# UNITED STATES PATENT AND TRADEMARK OFFICE

APPLICATION NO.	FILING DATE	FIRST NAMED INVENTOR	ATTORNEY DOCKET NO.	CONFIRMATION NO.
10/509,038	09/27/2004	Lutz Finn	1454.1568	1541

**Office Action Summary**

## **DETAILED ACTION**

Fig. 4

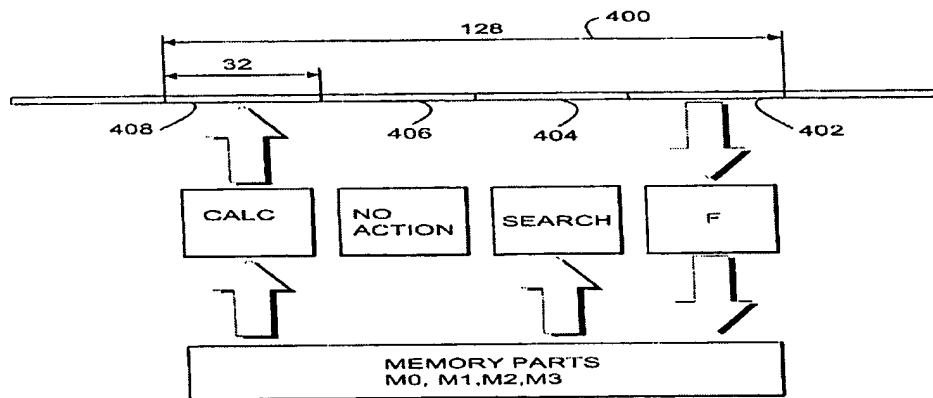
As per claims 7-8 and 14-15, Nieminen substantially teaches, in view of above rejections, (Figure 4) a sliding window 400, the length of which is in this example 128. The sliding window is divided into four parts 402 to 408, the length of each part being 32. In the first part 402 of the sliding window, computation is performed in the forward-direction, i.e. from left to right. The data is read from the first memory, and the resulting data is stored in one of the parts M0 to M4 of the second memory. In the second window 404, the computation unit performs the learning period, reading data from one of the parts M0 to M4 of the second memory. This computation proceeds from right to left. There are no activities in the third part 406 of the window, whereas in the fourth part, actual computation is performed reading data from one of the parts M0 to M4

of the second memory. This computation also proceeds from right to left. This uses different parts of the memory.
